MONTICELLO NUCLEAR GENERATING PLANT
Docket No. 50-263 License No. DPR-22

Supplement No. 1 to License Amendment Request
Dated September 2, 1977

RESPONSE TO NOVEMBER 2, 1977 REQUEST FOR ADDITIONAL INFORMATION
MONTICELLO NUCLEAR GENERATING STATION
CONTAINMENT LEAK TEST DURATION

FIGURE 8-1

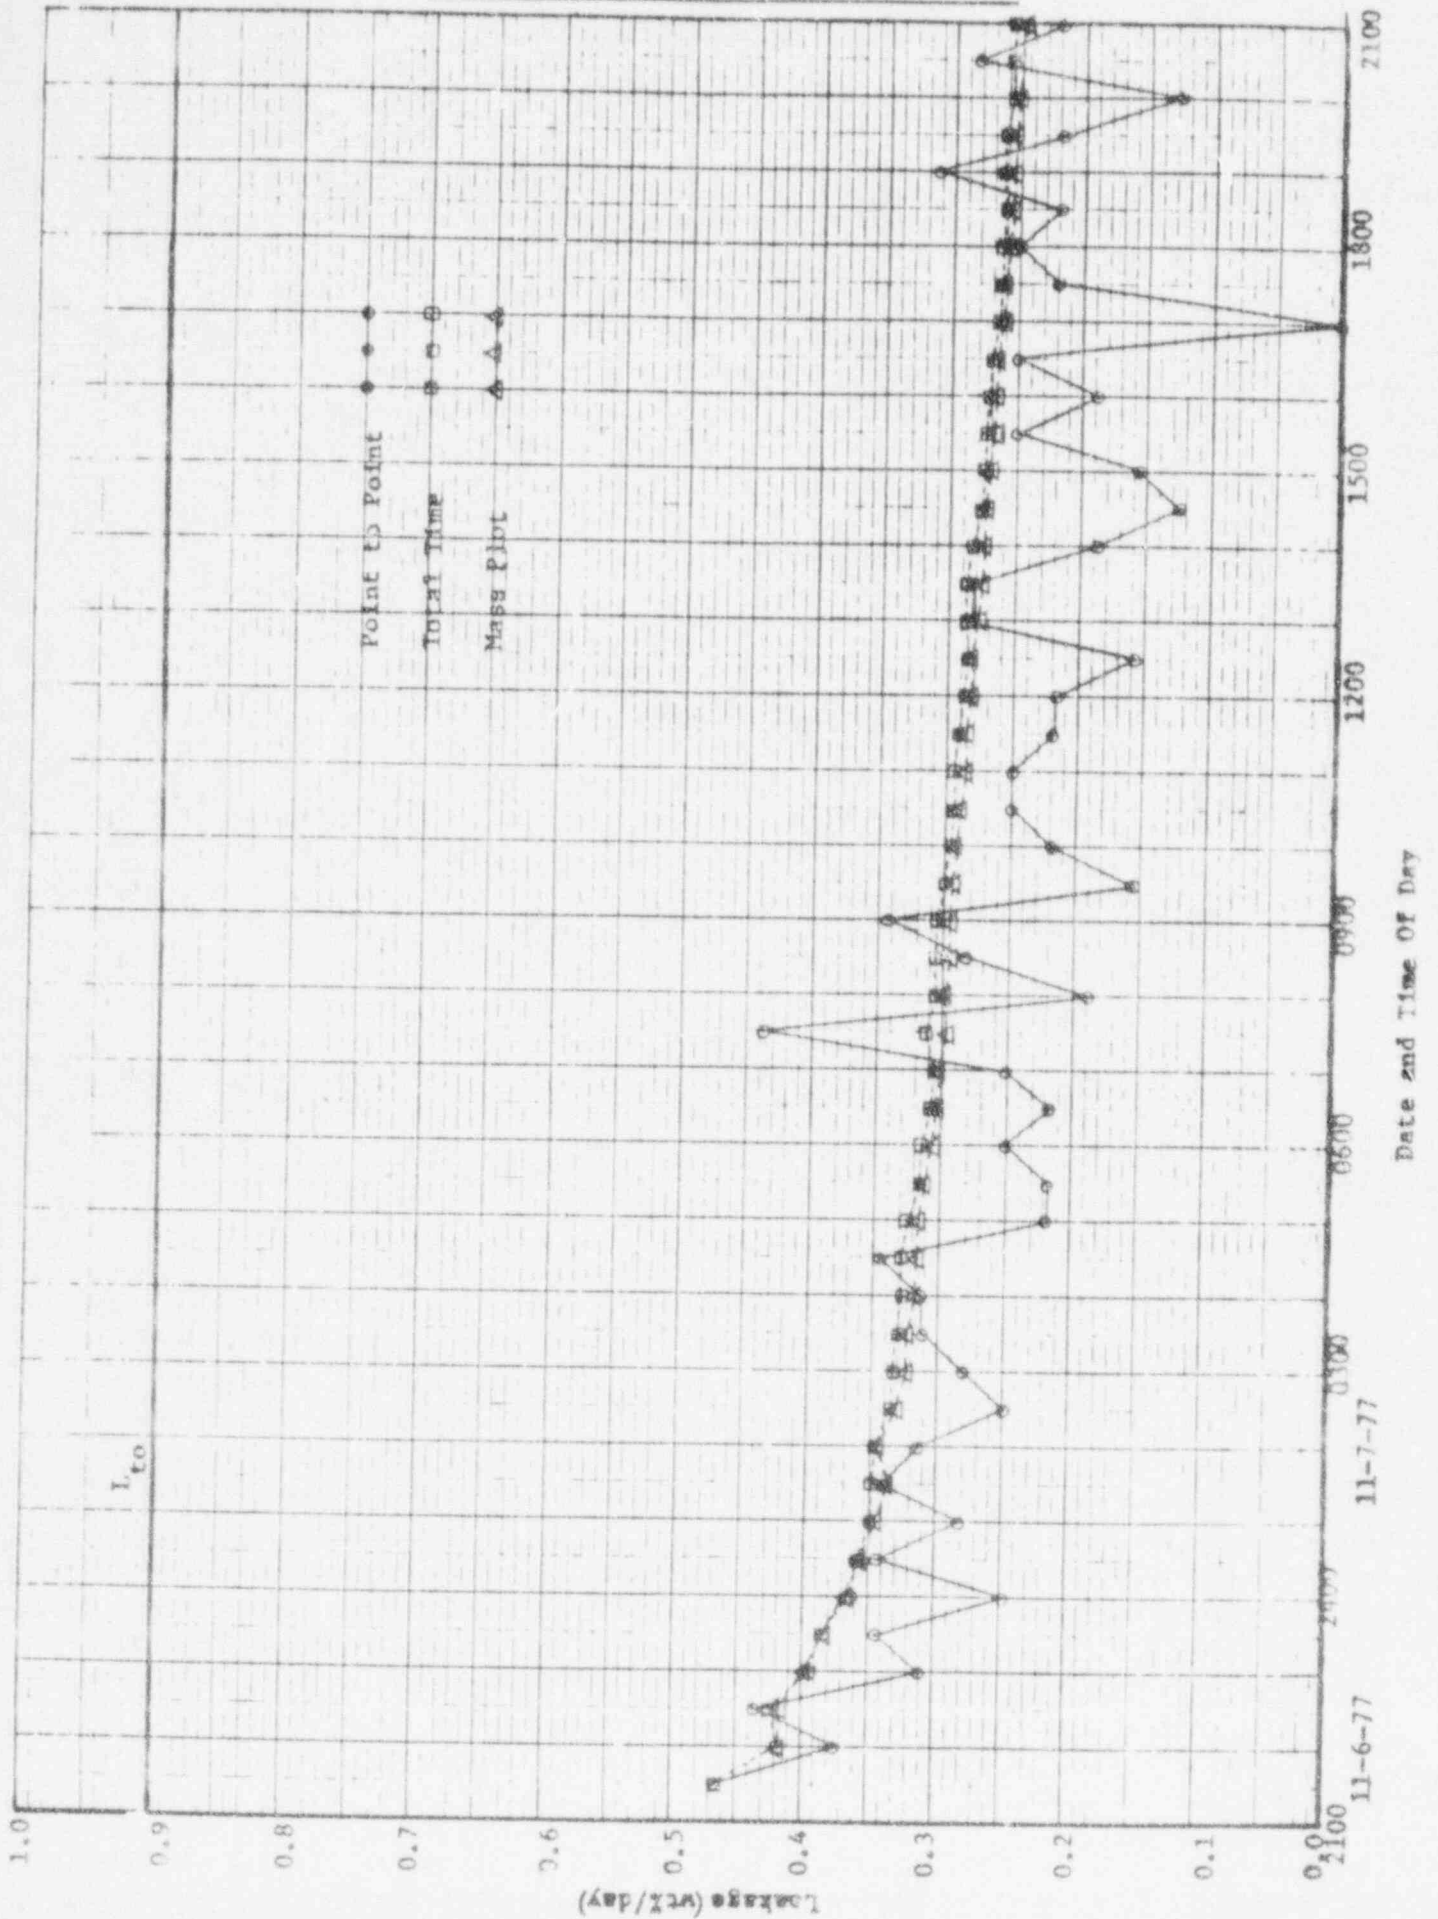
8. Previous testing experience has shown that there are a number of effects which become more pronounced as the CILRT duration decreases. In many cases, these effects are not adequately reflected in the confidence limits of the CILRT results. Demonstrate that the proposed minimum test duration in conjunction with the proposed testing procedure will adequately reflect each of the following effects:

- a) the containment volume change following pressurization;
- b) outgassing and ingassing during and following containment pressurization;
- c) the variation of internal system heat loads; and
- d) diurnal effects relating to variations in the temperature of containment cooling water.

The effect of ingassing and outgassing is evident in plots of containment leakage rate versus time. As shown in the plot for the 1977 Monticello CILRT, ingassing generally results in a higher leak rate during the initial phases of the test and outgassing results in a lower leak rate during the final phases of the test. (Figure 8-1). Terminating the test following eight hours of data collection would result in a more conservative leakage rate measurement than the measurement obtained after 24 hours of testing.

We have been unable to detect any diurnal variation in containment leak rate versus time. Refer, for example, to Figure 8-1 which shows no dependence on time of day. Plots of all Monticello CILRT results may be found in References (3) through (7).
